STAFF REPORT
COMMUNITY DEVELOPMENT DEPARTMENT

HEARING DATE: 9/6/2022
 TO: Mayor & City Council
 FROM: Joe Dodson, Associate Planner
 208-884-5533
 SUBJECT: H-2022-0036
 Lavender Place Subdivision
 LOCATION: The site is located at 2160 E. Lake Hazel Road, approximately 1/4 mile east of S. Locust Grove on the north side of Lake Hazel, in the SE 1/4 of SW 1/4 of Section 32, Township 3N, Range 1E.

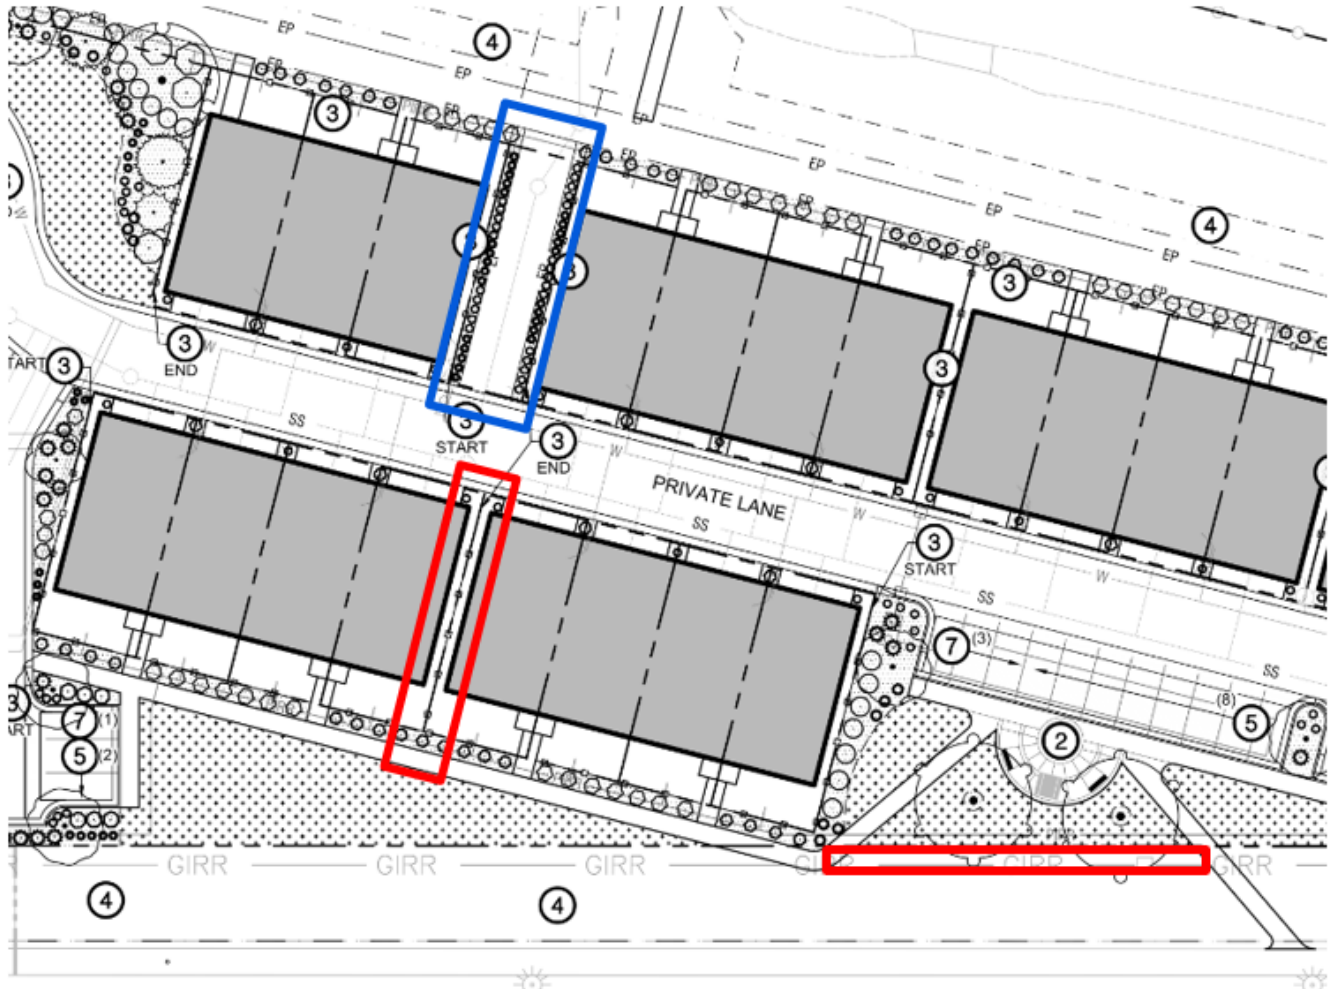
Per the submitted parking exhibit (see snip below), the Applicant is proposing to alternatively comply with the off-street parking standards by providing 18 parking spaces that will be designated for each specific unit. Each of the proposed residential units is shown with a 2-car tuck under garage providing the required off-street parking for 2-bedroom homes and meets the requirement of a 2-car garage for 3-bedroom units. However, due to the odd-shape of the parcel that creates a constrained building area, the Applicant proposed private streets and an alley-loaded product that does not readily allow for the required 20' by 20' parking pad for the nine (9) 3 and 4-bedroom homes. The Applicant placed the parking spaces directly across the private street from each unit to minimize the distance homeowners would have to traverse to access their additional parking spaces. In addition to the 18 parking spaces designated for the residents, the Applicant is also showing 7 additional guest parking spaces. NOTE: Parking is prohibited on the private street as well as along Lake Hazel and Bloomerang, the collector street where the private street takes access from.

Staff finds the proposed alternative as one option to meet the intent of the off-street parking requirements when accounting for the required density of the existing Development Agreement, site constraints, and limited access for the site. However, upon further review, Staff is recommending a modification to the ALT request: Staff recommends one parking space is allocated for each 3 or 4-bedroom unit instead of two spaces. It is difficult to predict the number of cars each unit will produce so Staff finds it more prudent to offer additional spaces for the entire development and not just the units with more bedrooms. Staff's recommendation would increase the number of guest spaces from seven (7) up to 16 spaces which should allow for more appropriate flexibility in their use for future residents and guests of this development. An additional option, should Commission or Council find the amount of off-street parking is not adequate overall, is to limit the number of units containing 3 or 4 bedrooms as a plat condition. Staff's Alternative Compliance findings for this request are below in Section IX at the end of this report.

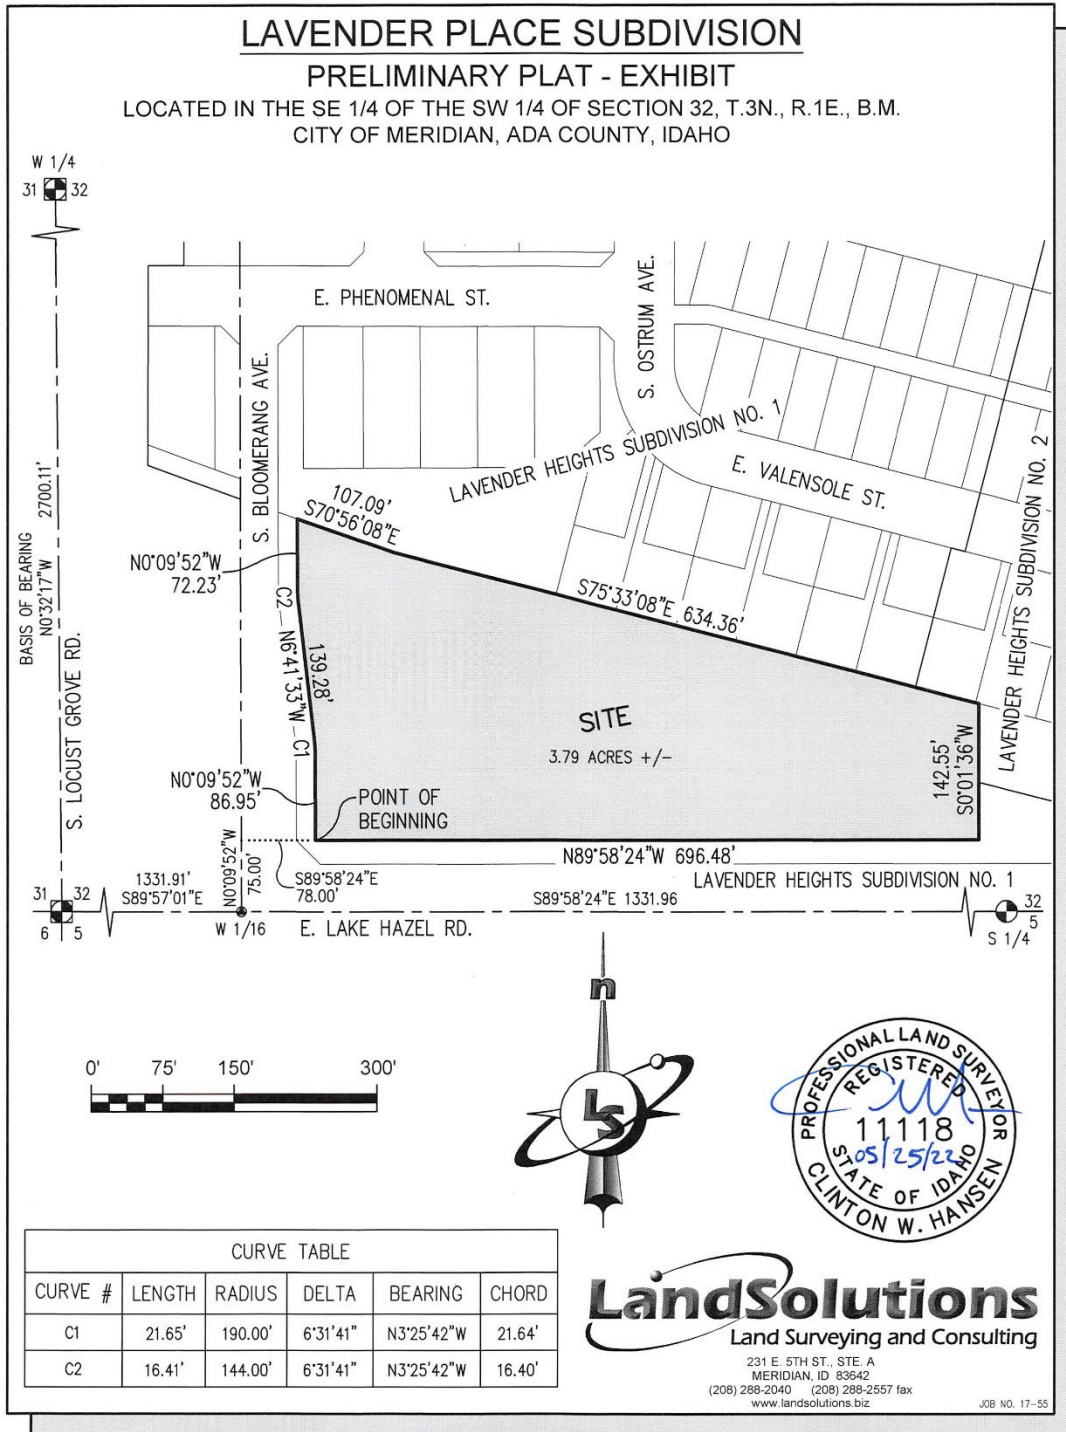
- a. Remove parking in hammerhead turnaround;
- b. Limit all units to no more than 2-bedrooms to help with parking and increase guest parking;

- a. Applicant has not removed parking in hammerhead in an effort to keep 3 additional guest parking spaces;
- b. **Applicant has revised parking exhibit per Staff's revised Alternative Compliance approval but requests to strike Commission's added condition regarding number of bedrooms per unit – Applicant has alternatively proposed to limit noted units to no more than 3-bedrooms and essentially provide 1 space per bedroom.**

4. City Council change(s) to Commission recommendation:
 - a. Strike condition limiting bedroom count and comply with Staff’s recommended ALT provision.

D. REVISED Parking Exhibit (~~NOT APPROVED~~):

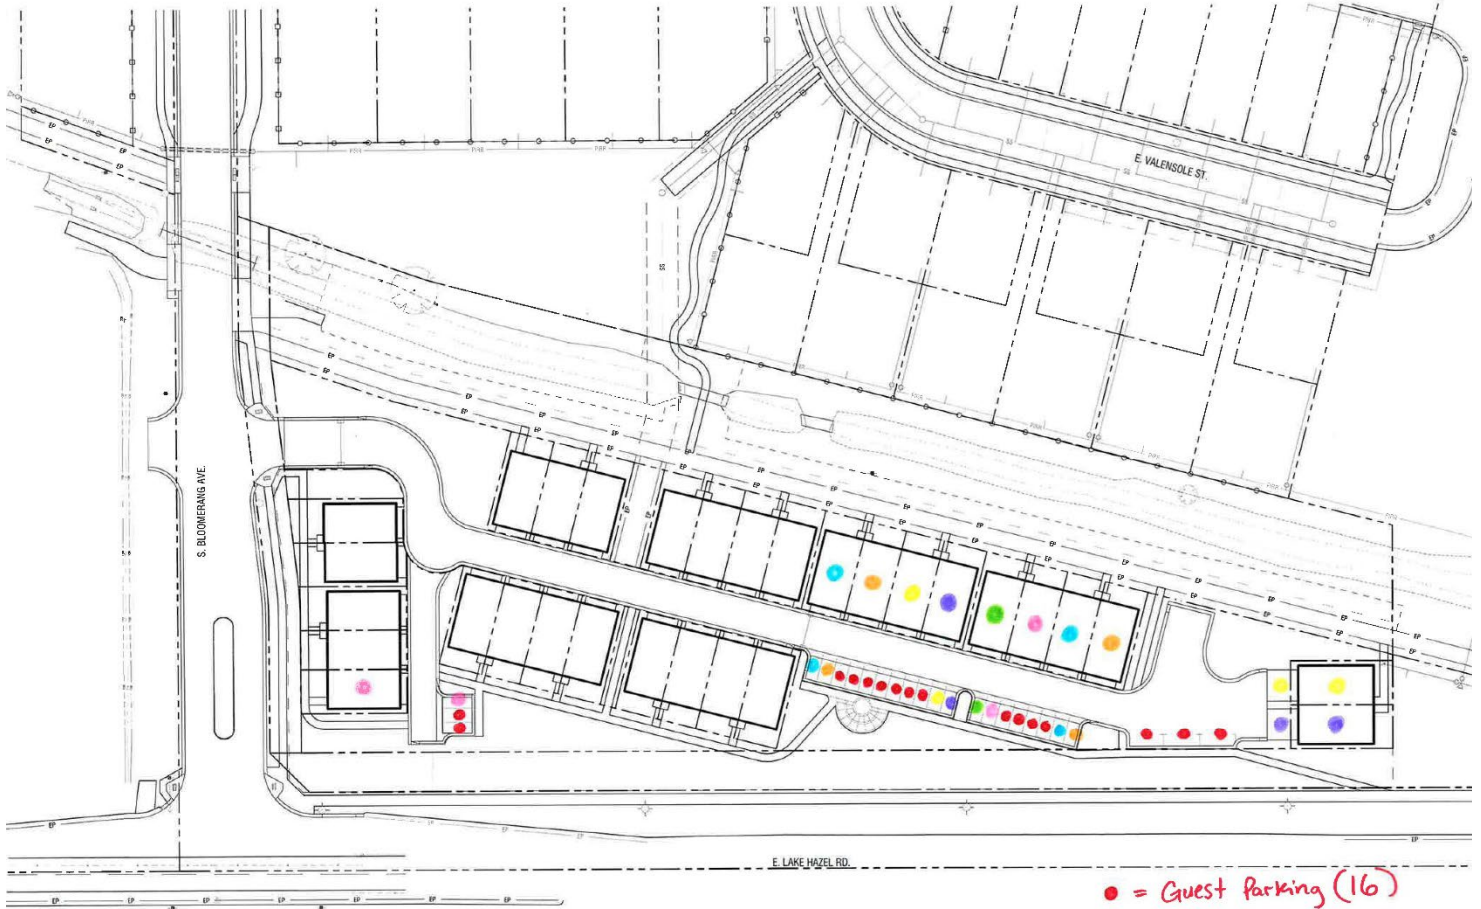
- d. ~~Revise the Alternative Compliance Parking Exhibit (Exhibit VII.D) to depict one (1) open parking space per 3 or 4 bedroom unit instead of two (2) consistent with Staff's analysis in Section V.H.~~

- e. ~~Revise the plat to remove the parking shown within the hammerhead turnaround at the terminus of the private street.~~
2. The landscape plan included in Section VII.C, dated ~~March 30~~ August 22, 2022, is approved as submitted, shall be revised as follows prior to the City Council hearing:
